OXY USA WTP LP - Proposed Stinking Draw #1 API No. 30-015-27891

## CONDITIONS OF APPROVAL FOR PLUGGING & ABANDONMENT

Operator: Oxy	USA	WTP	<u> </u>		
Well Name & Num	ber: <u>5</u>	tin kin	ig Draw	#1	
API#: 30-01	5-278	391			_

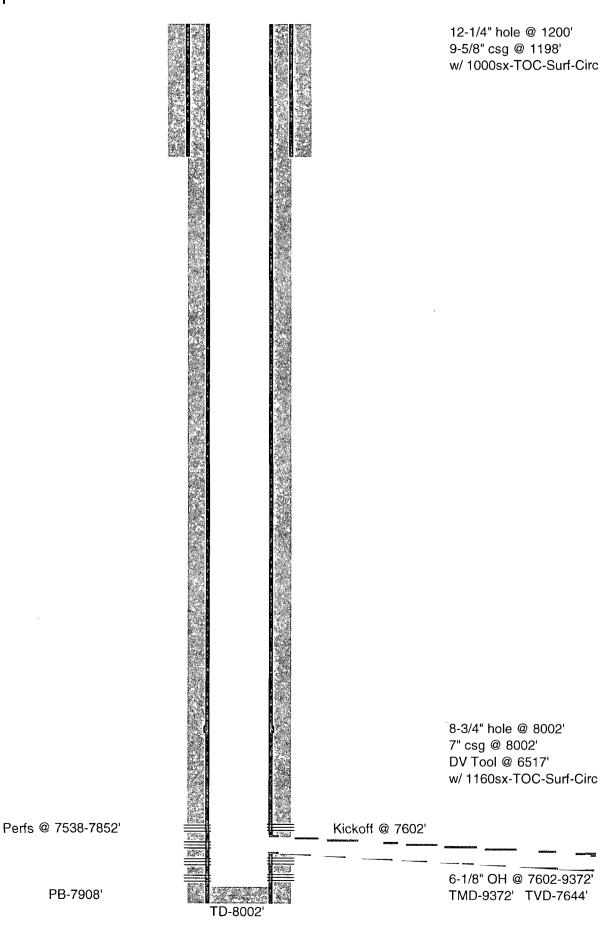
- 1. Produced water <u>will not</u> be used during any part of the plugging & abandonment operation.
- 2. Notify NMOCD Dist. 2 office at least 24 hrs before beginning work.

- 3. Closed Loop System is to be used for entire plugging operation. Upon completion, contents of steel pit are to be hauled to a permitted disposal location.

- **4.** Trucking companies being used to haul oilfield waste fluids to a disposal commercial or private shall have an approved NMOCD C-133 permit. A copy of this permit shall be available in each truck used to haul waste products. It is the responsibility of the operator, as well as the contractor, to verify that this permit is place prior to performing work. Drivers shall produce a copy upon request of NMOCD Field Inspectors.

- 5. A subsequent C-103 will serve as notification that the well bore has been plugged ONLY. A C-103 FINAL shall be filed before any bonding can be released on the well. Upon receipt of the Final, an inspection will be performed to verify that the location has been satisfactorily cleaned to NMOCD standards.

- **6.** If work has not begun within 90 days of the approval of this procedure, an extension request must be filed, stating reason that well has not been plugged.

- 7. Every attempt must be made to clean the well bore out to below the perfs, before any plugs can be set, by whatever means possible.
- 8. Cement Retainers may not be used.

- 9. Squeeze pressures are not to exceed 500 PSI, unless approval is given by NMOCD.
- 10. Plugs may be combined after consulting with and getting approval from NMOCD.
- 11. Minimum WOC time for tag plugs will be 4 Hrs.
